October 13, 2020

RE: SSC Cortlandville II LLC and SSC Cortlandville II LLC
Delta Project No.: 2020.260.001 and 2020.261.001

Please accept this letter in response to Mr. Renzi's Comments on Agenda Items memo dated September 29, 2020.

CVIII-200

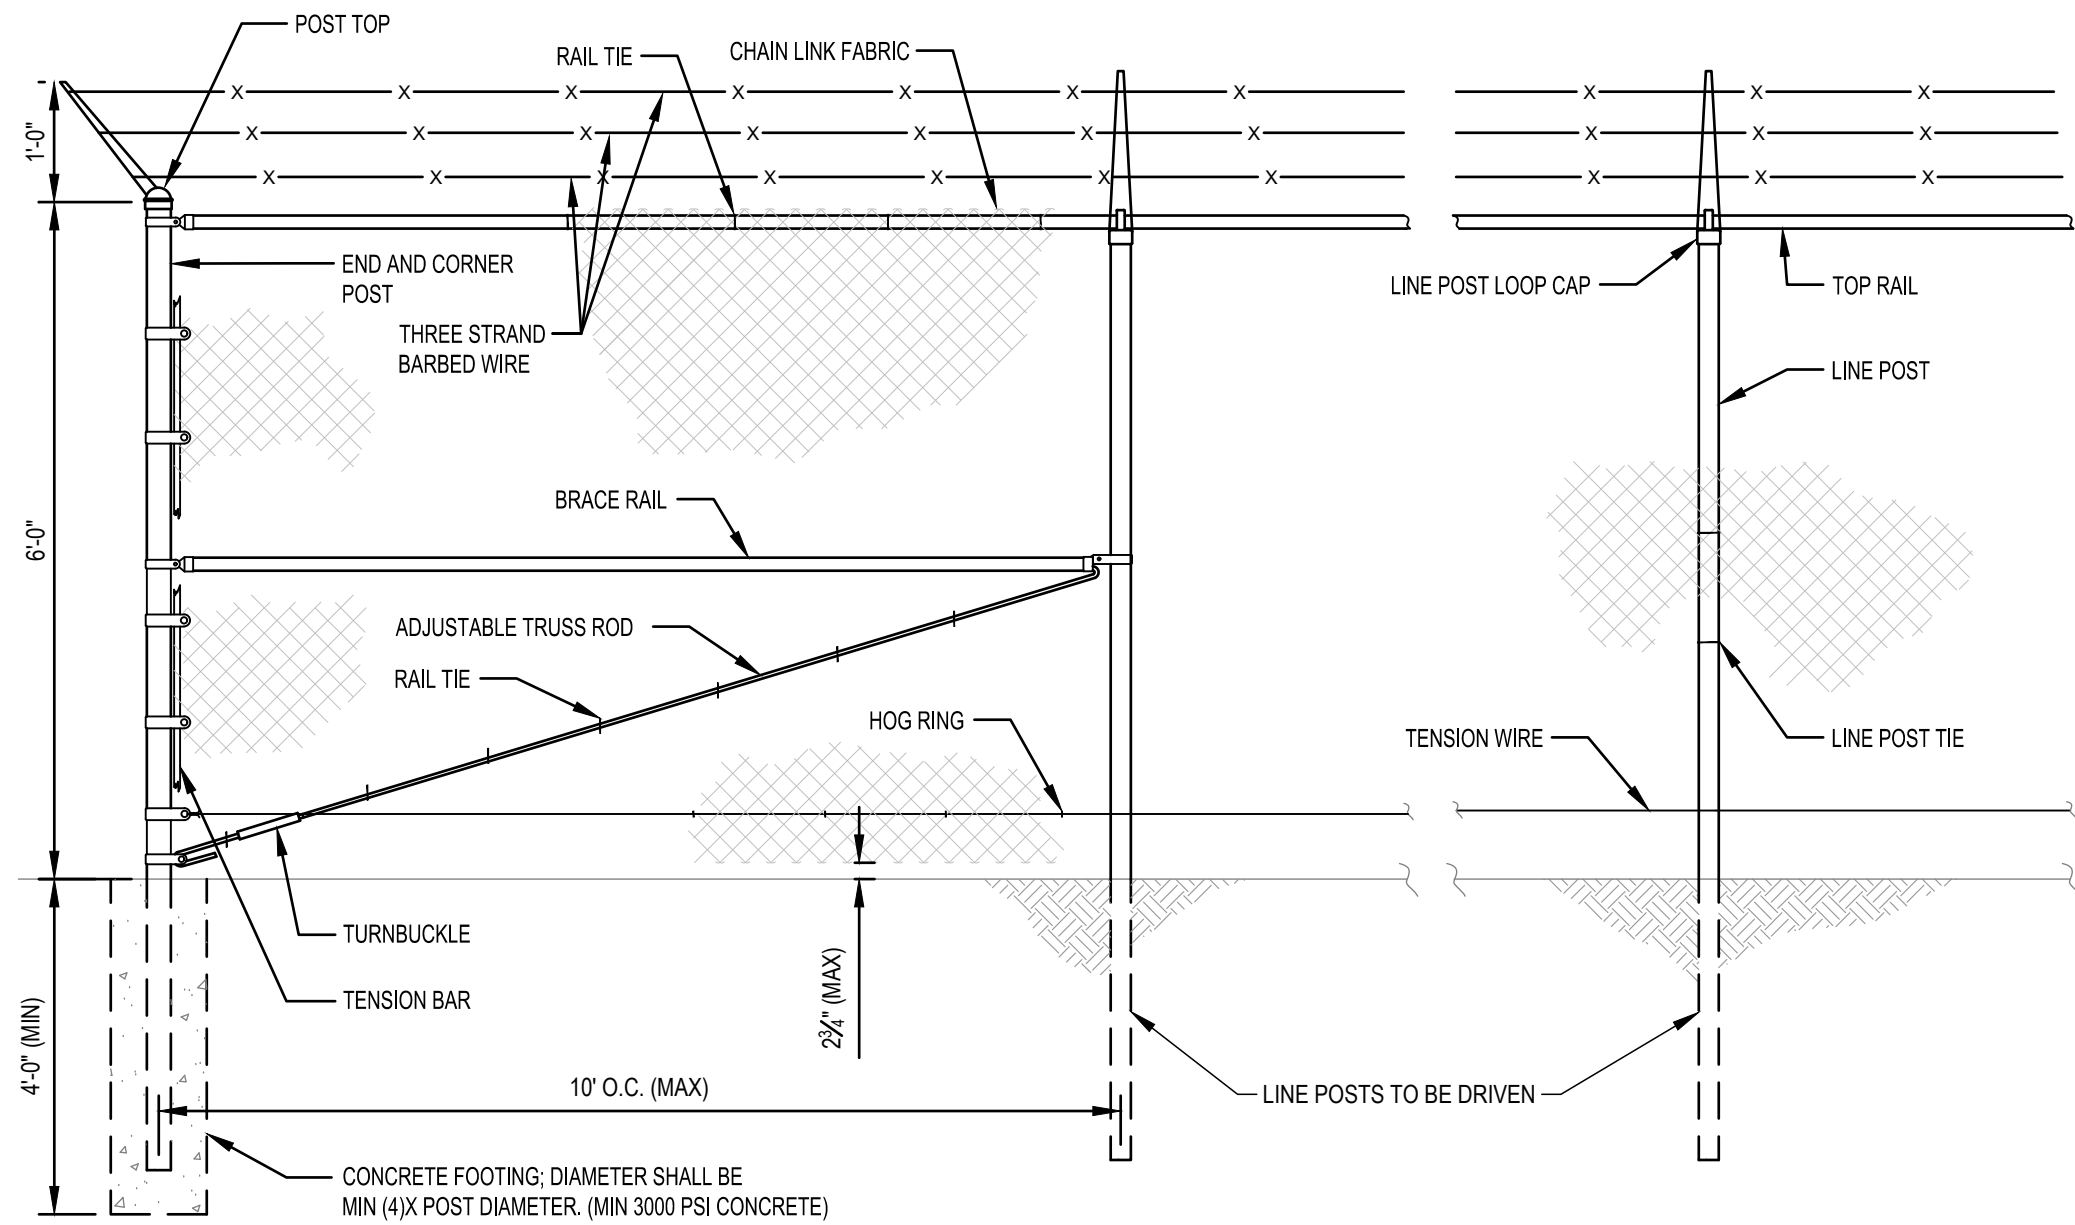
12	VIEW MITIGATION PLANTING. SEE DETAIL 6/CVIII-301.
